**ITEM FOR ENVIRONMENTAL COMMISSION AGENDA**

Case Number: **1881 Westlake Drive SP-2021-0349D**

Variance Request: **LDC 25-8-281(C)(2)(b) - To allow construction within 150 feet of a Rimrock Critical Environmental Feature (CEF) .**

## **ENVIRONMENTAL COMMISSION MOTION 20220518 004a**

1881 WESTLAKE DRIVE  
PROPOSED CONDITIONS SITE PLAN

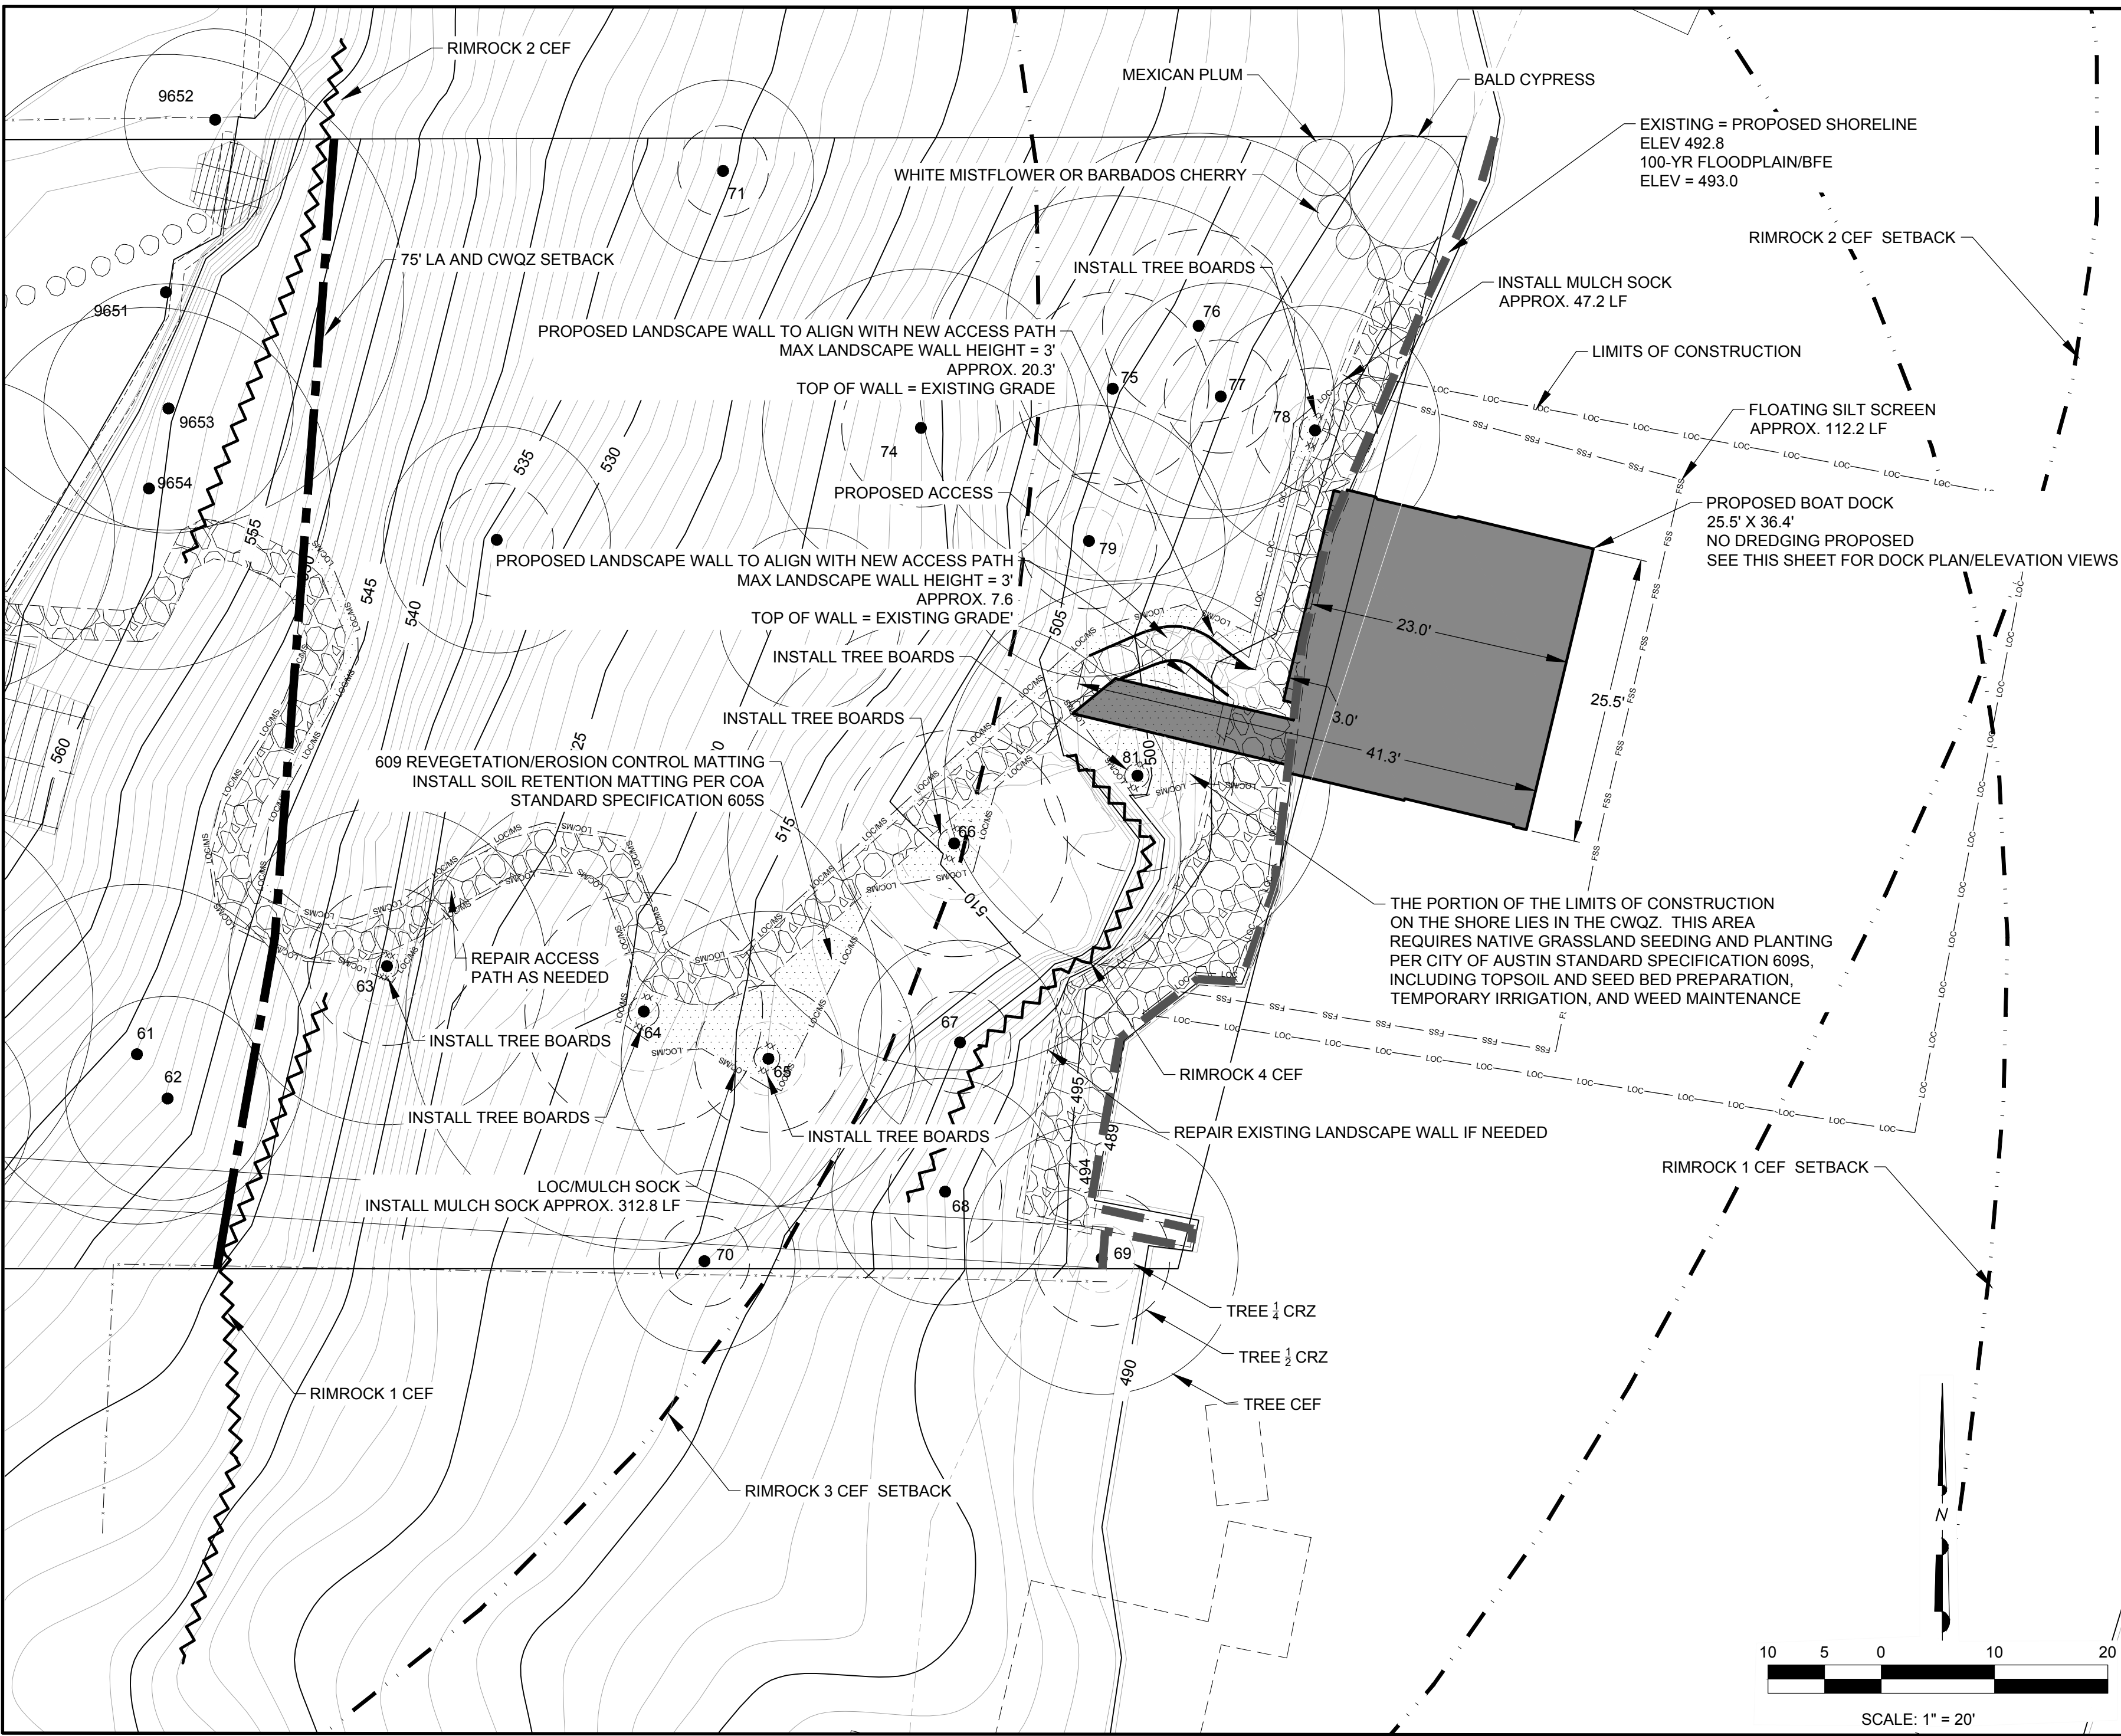
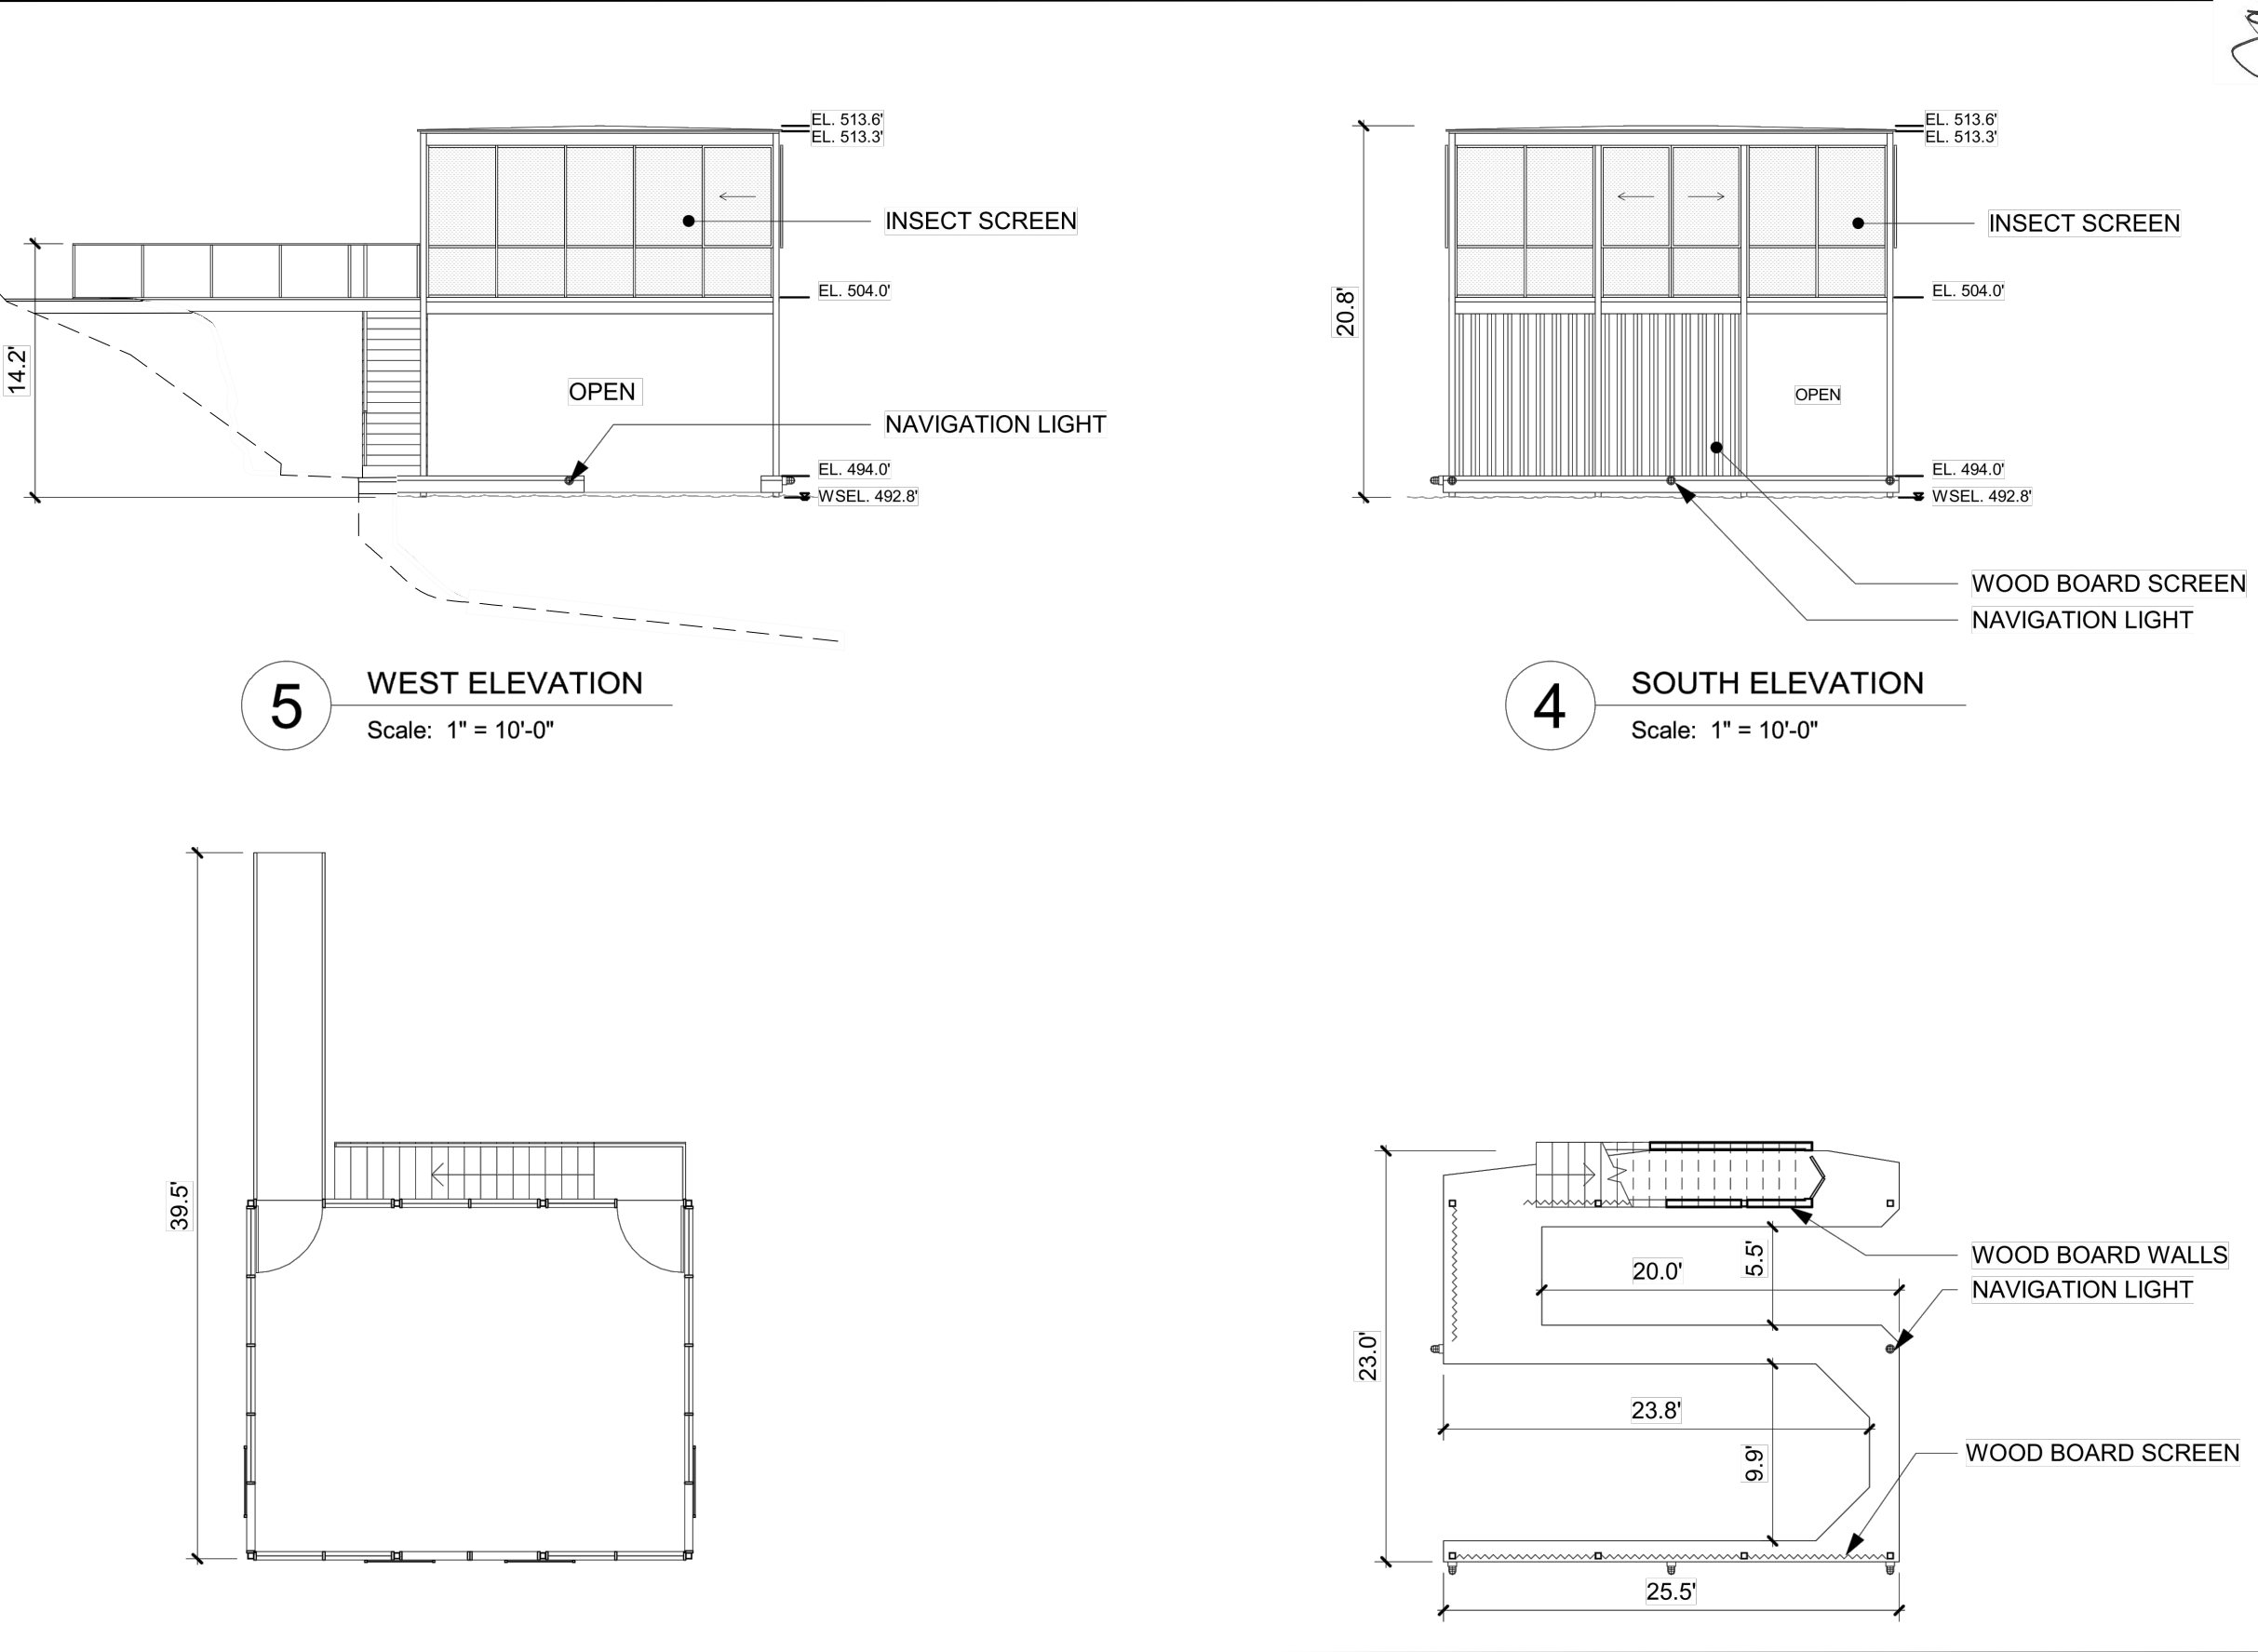
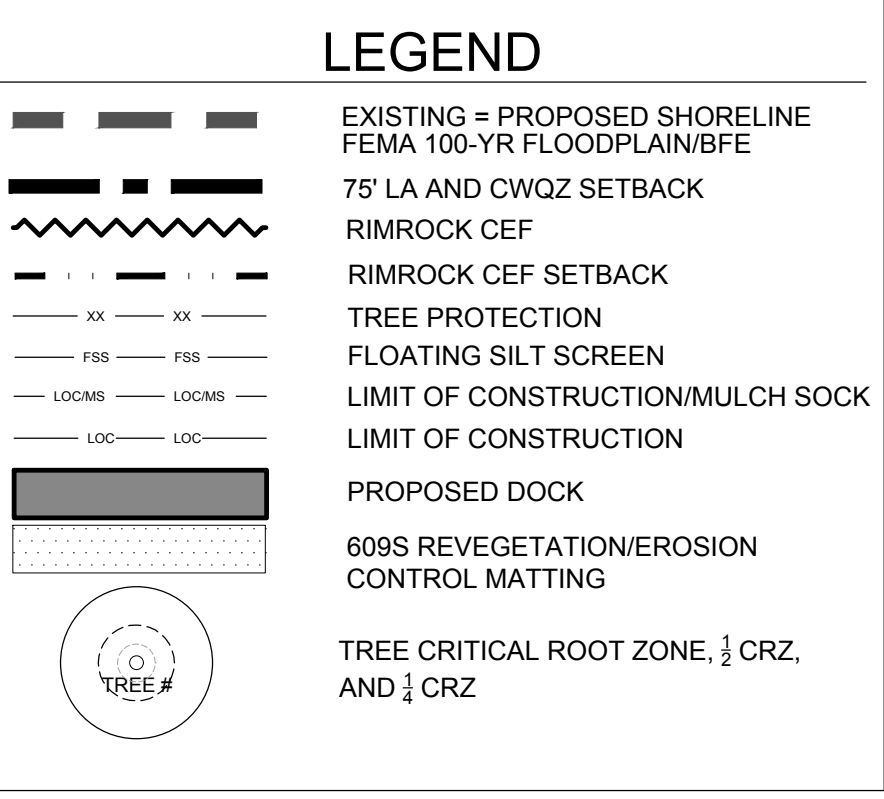
**Yes. No disturbance of the rimrock CEF is proposed, all proposed construction activities are to occur downgradient of the rimrock CEFs, and construction is to occur from the lakeside by barge. The proposed construction to be performed from a barge provides greater overall environmental protection.**

**Yes. The variance is the minimum deviation from the code requirement to allow for a reasonable use of the property. The code requires a 150-foot critical environmental feature buffer. This buffer is not being reduced. The scope of the variance is limited to allowing construction activities to occur within a critical environmental feature buffer only for the proposed boat dock replacement.**

**Yes. The variance does not create significant harmful environmental consequences. The construction of the boat dock from barge will not disturb the rimrock critical environmental feature.**

Clearly indicate in what way the proposed project does not comply with current Code (include maps and exhibits)	<i>The limit of construction for the proposed dock and access repairs fall within the rimrock CEF setbacks. Please see Attachment 2 for the Proposed Conditions Site Plan Sheet; Attachment 3 for the Basis of Determination for the Findings of Fact; and Attachment 4 for the Environmental Resource Inventory.</i>
---	---

**Staff Recommendation:** Staff recommends the variance as the Findings of Fact have been met, with the staff recommended condition that all construction be completed by barge.

1. Remove existing boat dock and access path as specified on plans.
2. restore disturbed areas per City Standard Specification 609S.
3. All construction to occur via barge.
